Date: January 23, 2002

Subj: Review of Third Runway Embankment Fill Monitoring Plan,
401 Certification Condition E.3
Port of Seattle, November 2001

Figure 1. Example Logic Tree Diagram for Groundwater Staged Screening. Third Runway Embankment Fill Monitoring Plan.

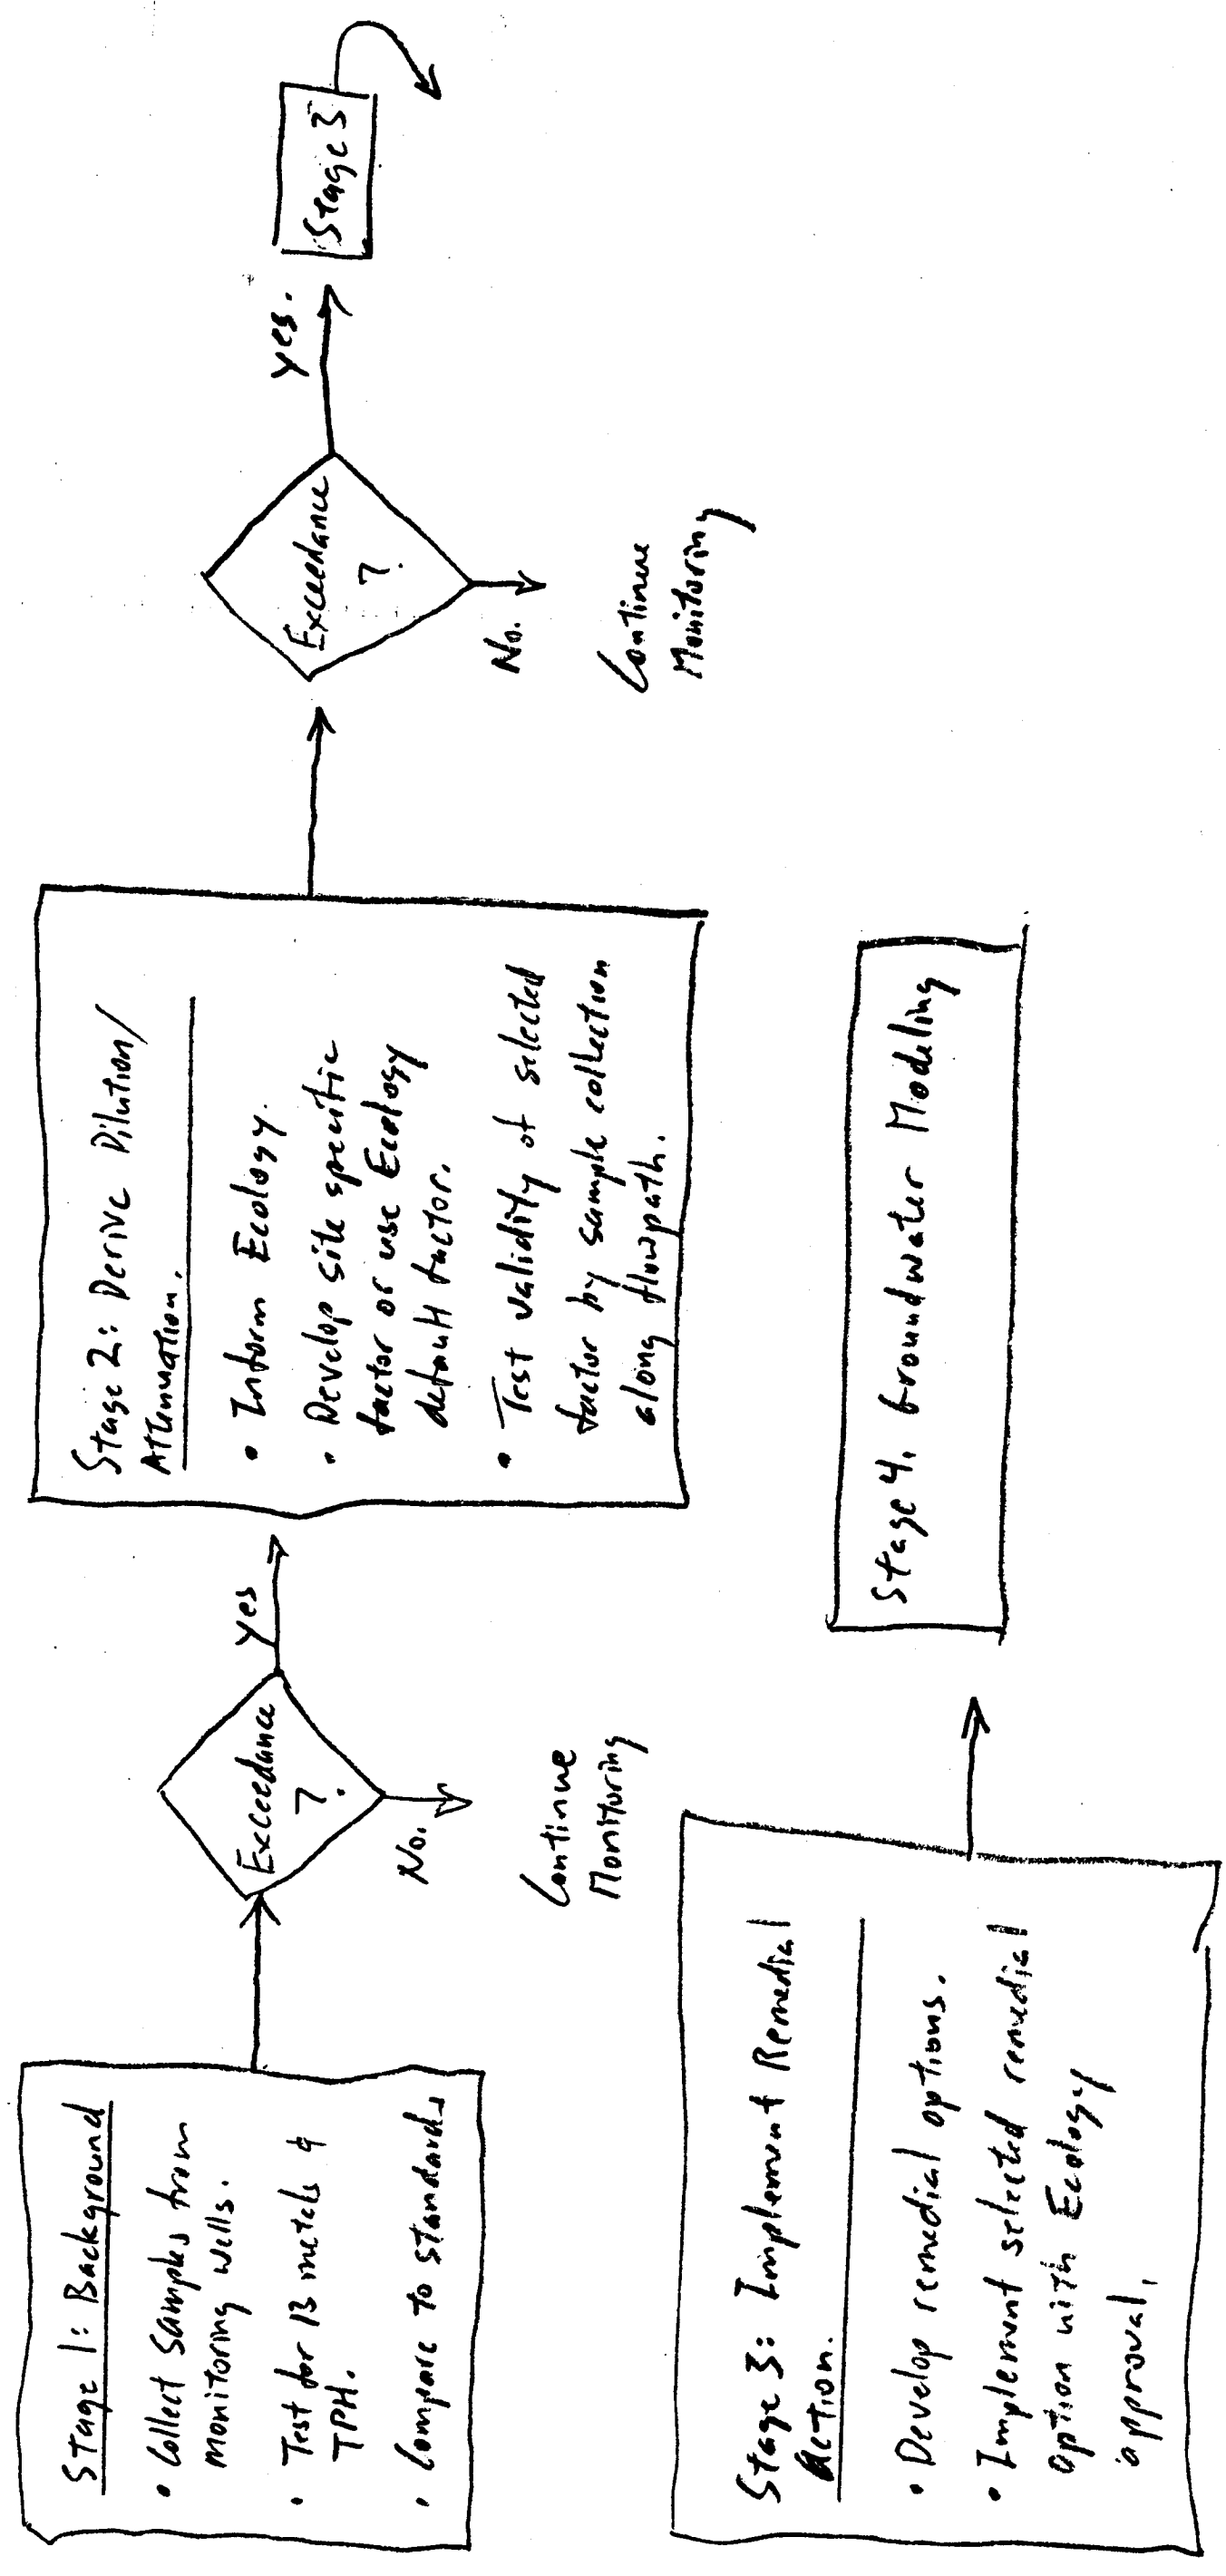
1. The document should provide detailed logic tree flow diagrams for the tiers and stages of sampling and action for all phases. I have provided an example logic tree flow diagram for the Groundwater Staged Screening that includes the comments provided in this memorandum (Figure 1). Similar logic tree flow diagrams should be provided in the EFMP for "tiers" sampling, Interim Seepage Quality Screening, Post Construction Embankment Seepage and Groundwater Monitoring, Seepage Staged Screening, and Groundwater Staged Screening.

12. Page 9, Section 5.0, first paragraph under section. A flow diagram would be most helpful to the reader not intimately familiar with the tiered approach. See comment number 1.
